Service Bulletin

SB-0046

SUBJECT: Outboard Oil Retention Kit

Figure 1

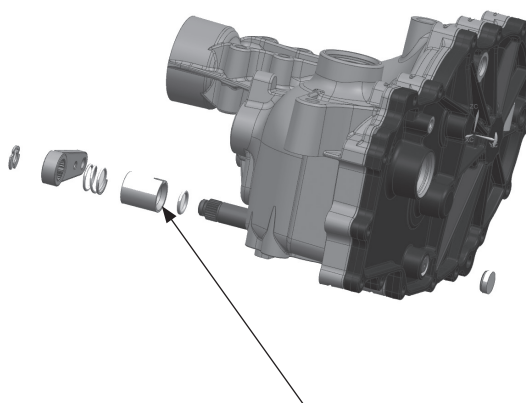
The kit will supply a brake bore plug that is to be seated into the housing over the brake shaft on the outboard side, (see figure 1).

Brake bore plug placement
